NASHPA COMPRESSION FACILITY PROJECT

Tender Enquiry No.: PROC/FC/CB/PROJ/NASHPA-3268/2018 PRE-BID CLARIFICATION # 12

One of the bidder has asked following queries, OGDCL/ENAR responses are as follows:

DRAWING TITLE: PIPING & INSTRUMENT DIAGRAM NASHPA H.P. PRODUCTION SEPARATOR (UNIT-21)

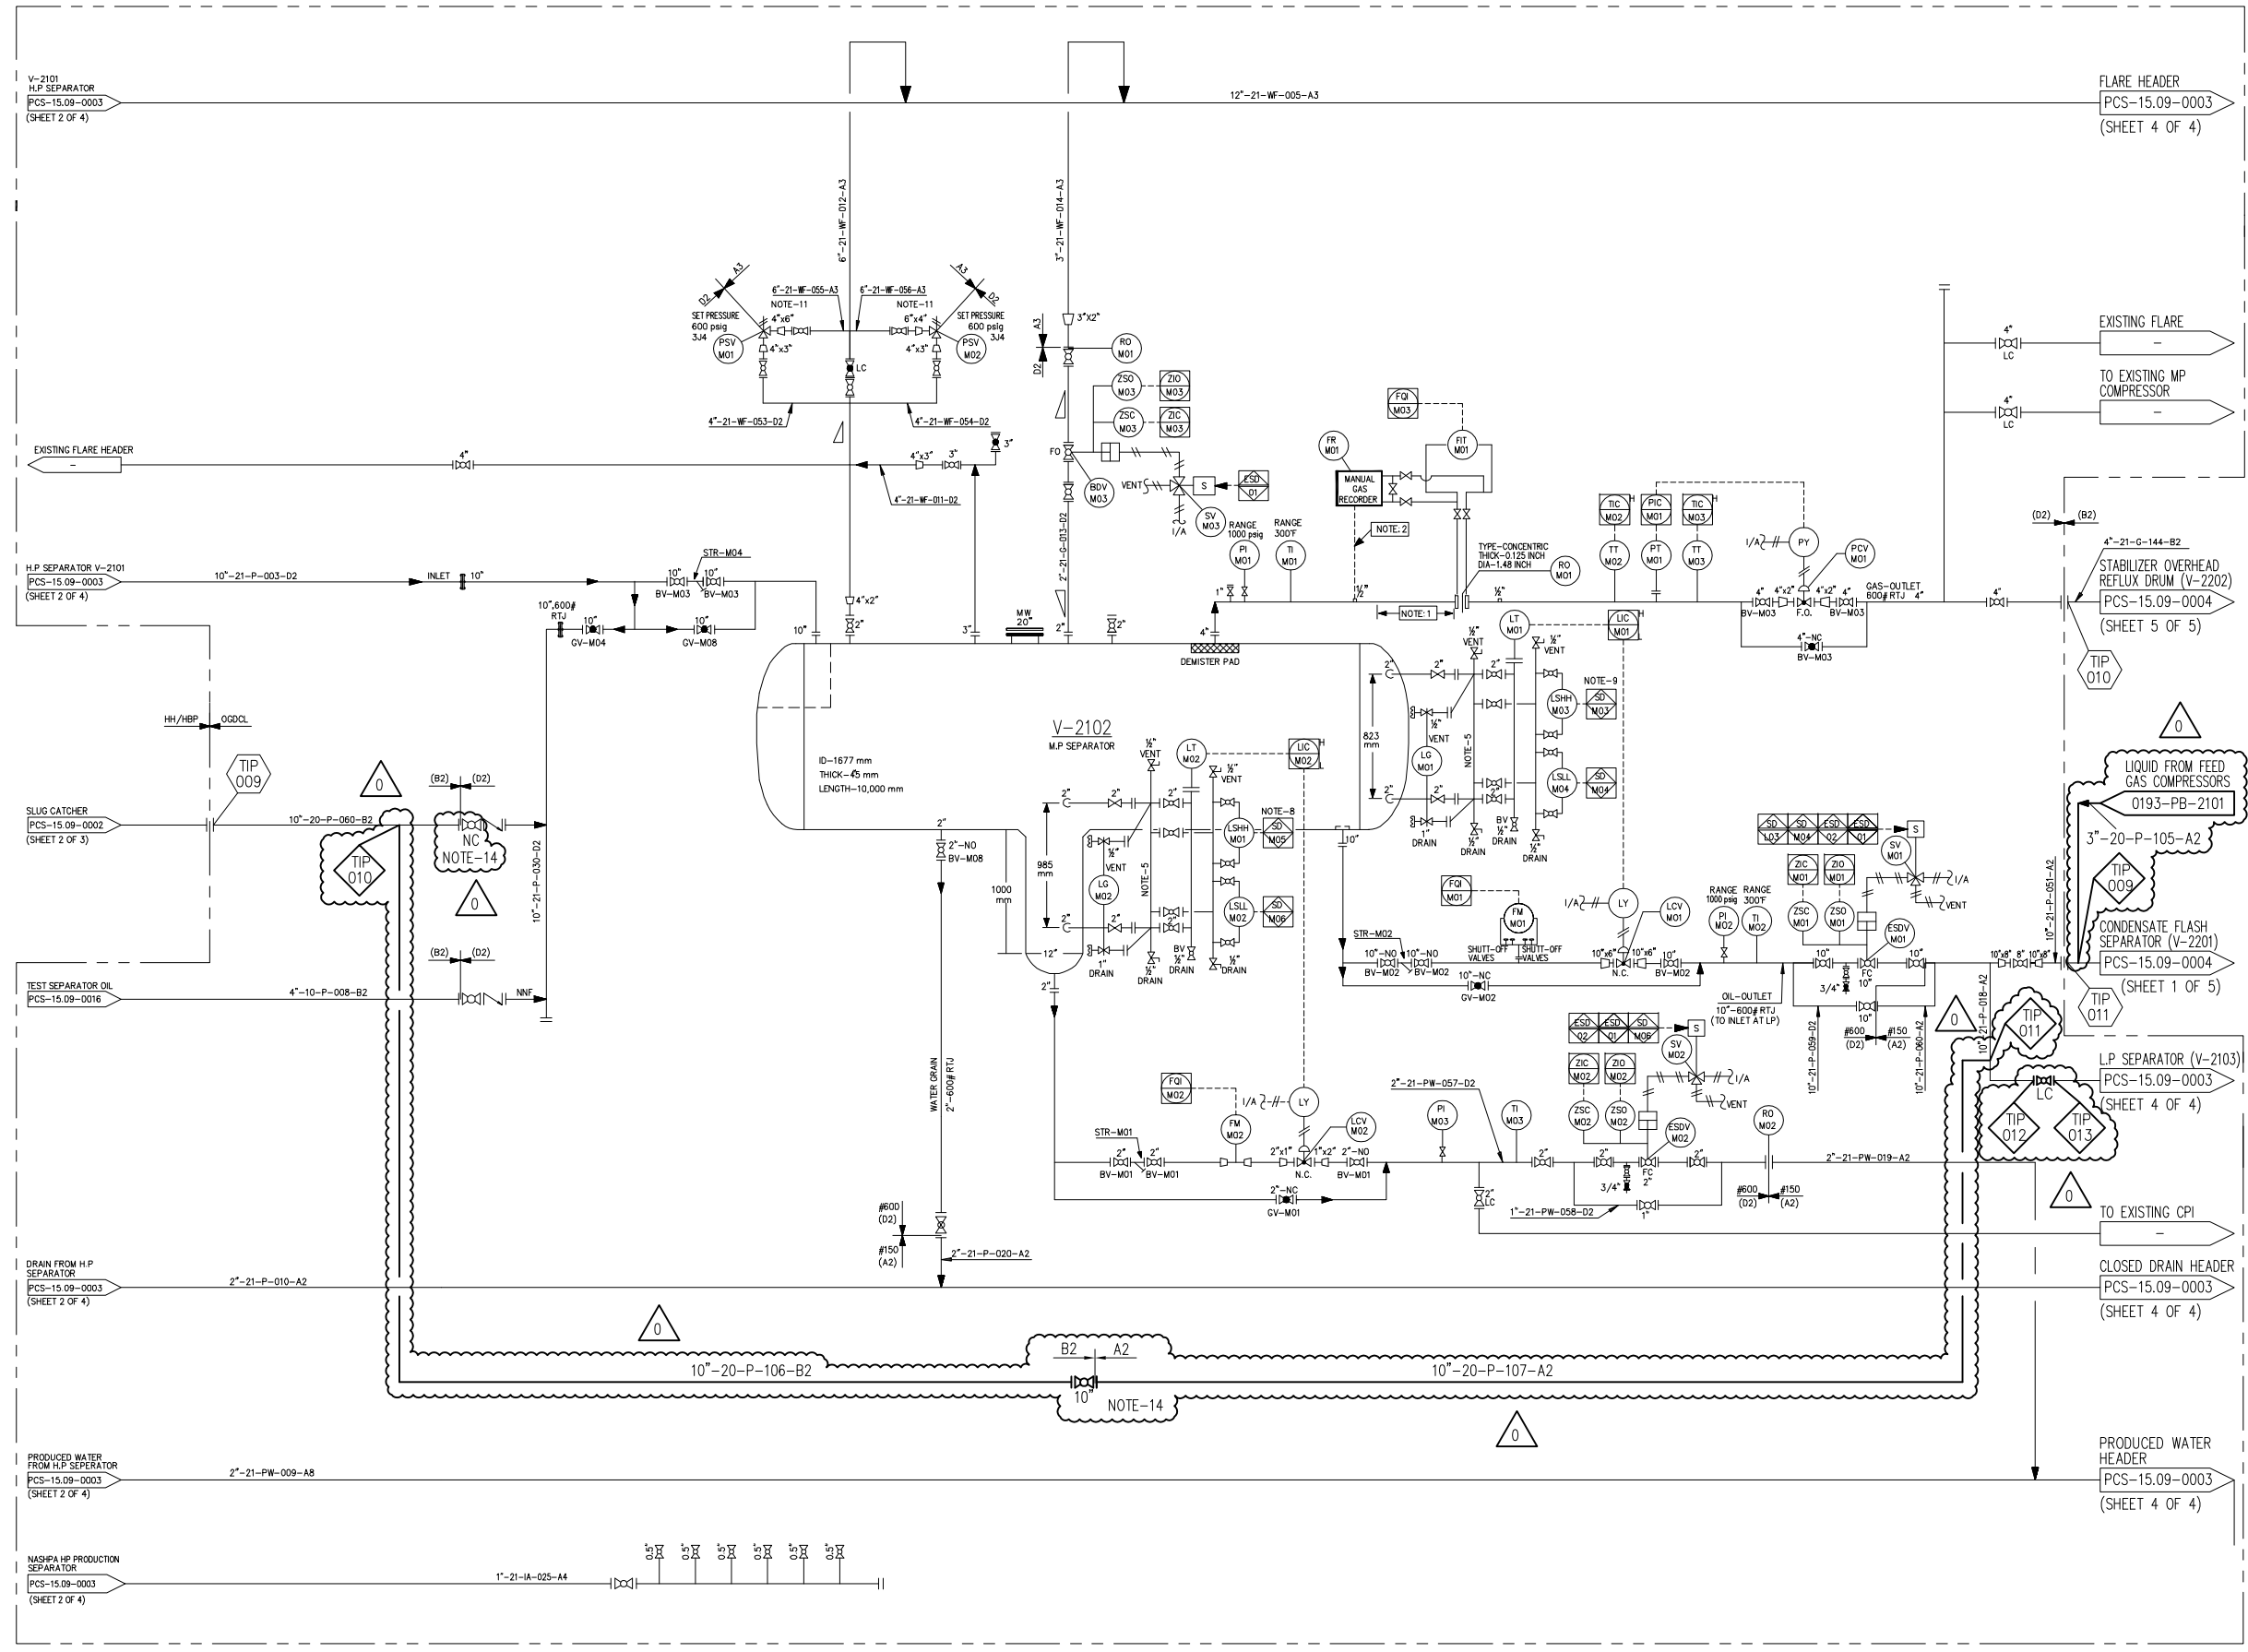
6	Bidder understand that existing fire water tanks, pumps and associated piping headers are adequate for the compression facility fire fighting however bidder to take respective tie-ins from existing fire water header and further to design, construct and installed proper fire fighting system for compression facility based on international codes and standards as specified in project ITB. Please confirm bidder understanding.	Refer Sec-III (Scope of Work)-sub-clause 2.3.3
7	Refer to proposed PFD of project highlighted total compressor facility manual by-pass arrangement however any such arrangement not found in ITB P&IDs. Please clarify whether overall compression facility manual by-pass (from slug catcher to Evaporative cooler EA-2101) shall be required or not ?	Overall compression facility manual by-pass (from slug catcher to Evaporative cooler EA-2101) is required and is already shown in P&ID# NGP-001-PCS-15.09-0003-02-0 Sheet 1 of 4 (P&ID For Nashpa H.P Production Separator).
